Subject: Regarding Grant of Environment Clearance for the Minor Mineral (River Bed Material) mining project in Bhini River in Block no. 7 Downstream Kishanpur Road Bridge , District Kathua , Jammu and Kashmir. Area- 6.90 ha.

Ref:-Proposal no:- SIA/JK/MIN/62463/2021

Subject: - Regarding Resizing of Minor Mineral Blocks No. 07, 08 & 09 in Bhini River, Tehsil Billawar and Minor Mineral Block No.23 in Johad Khad, District, Kathua.

Minor Mineral Block No. 07, Bhini River Downstream Kishanpur Road Bridge, District Kathua (Plan- II) in favour of Sh. Kishori Lal.

REVISED SITE PLAN SHOWING MINOR MINERAL BLOCK IN BHINI RIVER DOWNSTREAM KISHAN PUR ROAD BRIDGE, DISTRICT KATHUA (PLAN-II)

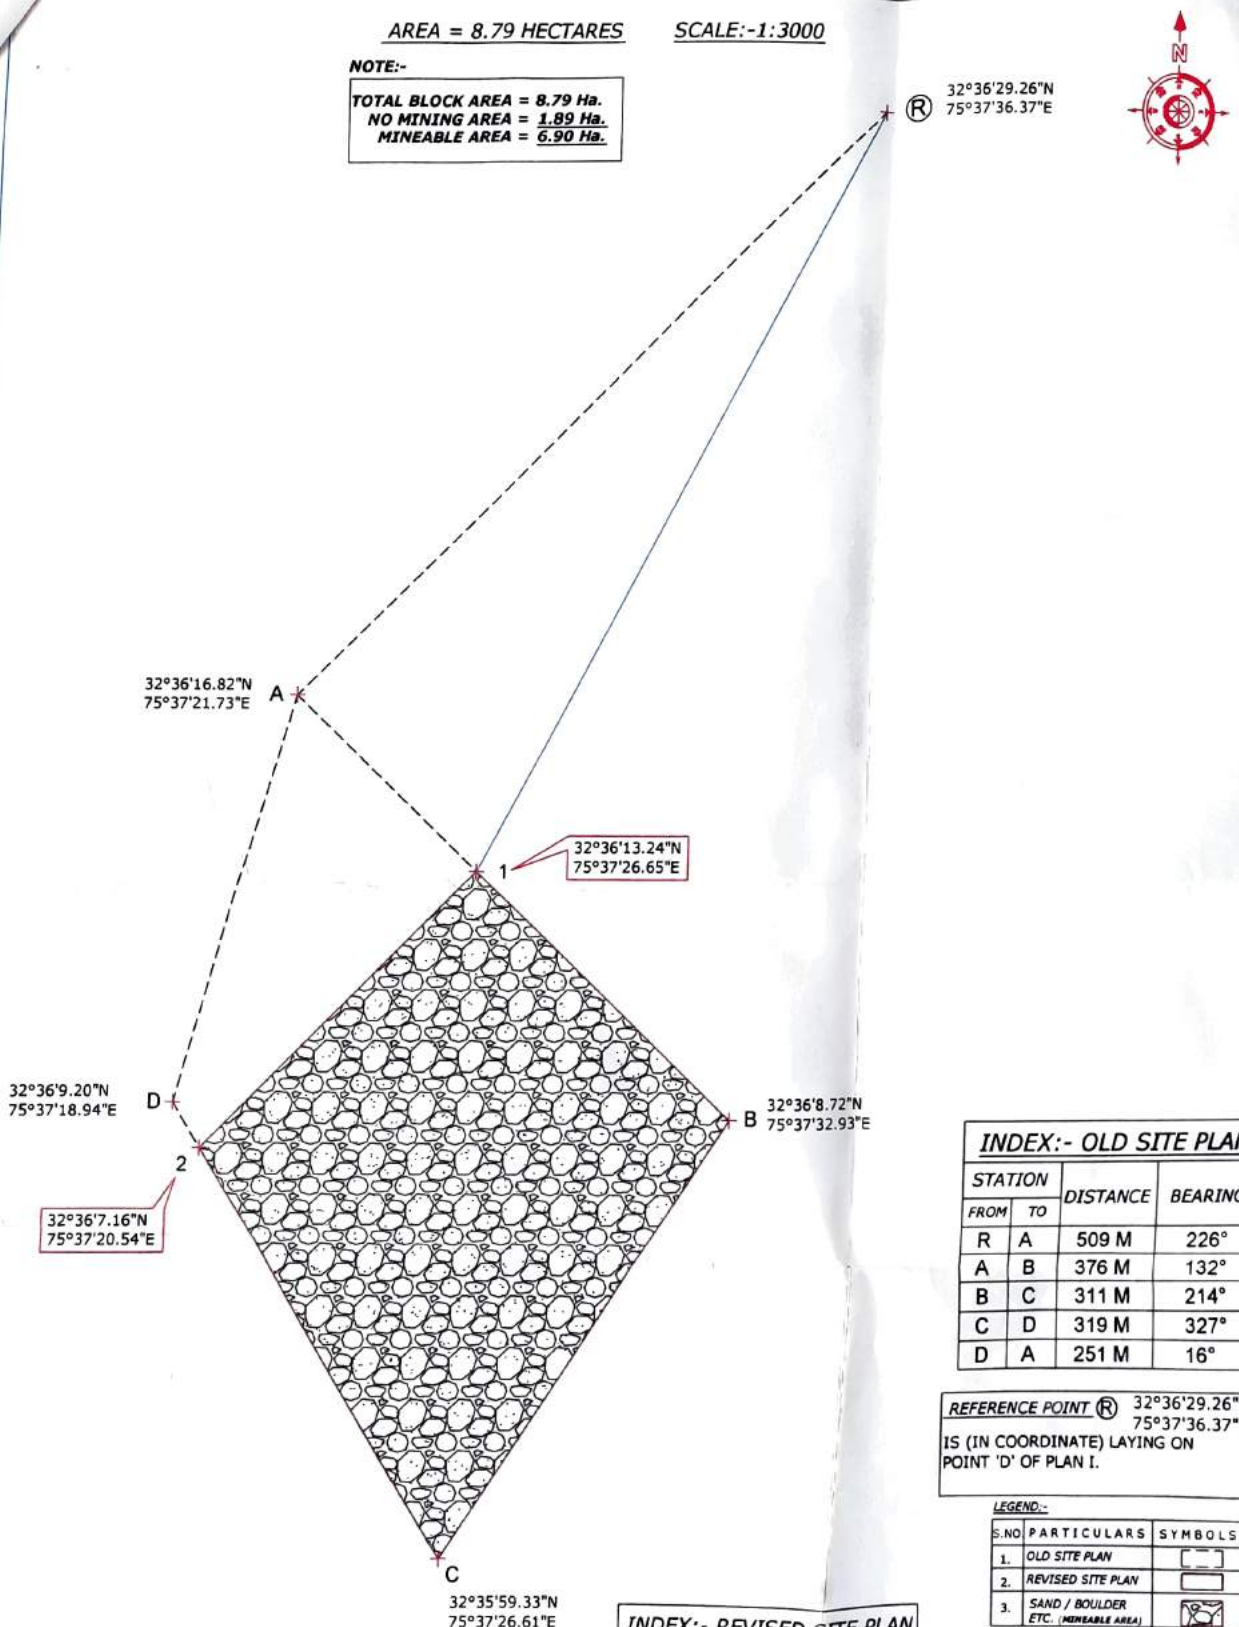
4. The Project Proponent submitted Mine Plan of Minor Mineral Block No. 07 to JKEIAA wherein it was pointed out by the JKEIAA vide letter No. JKEIAA/2021/563/1766-70 dated 13-07-2021 that the Mining Block be resized /relocated or re-aligned along the flow of the nallah and haulage route does not traverse through the active water channel. Accordingly, the Project Proponent submitted revised site plan to Director, Geology and Mining office, Jammu which was forwarded to this office for scrutiny and ground check by DGM office vide letter No. mentioned above.

5. The area proposed for reduction from the Block is 1.89 hectares (No Mining area) and Mineable area of the Minor Mineral Block left is 6.90 hectares.

6. On scrutiny of the revised site plan it has been observed that point "1" having Geo-coordinates 32°36'13.24"N 75°37'26.65" E is located between points "A" and "B". Similarly point "2" having Geo-coordinates 32°36'7.16"N, 75°37'20.54"E is located between points "C" and "D" .

In light of the facts stated above, it is submitted that the Geo-coordinates of point "1" and "2"of the revised site plan falls within the Geo-coordinates of Site Plan/Mine Plan already approved by the District Mine Plan Approving Committee vide No. and date mentioned above.
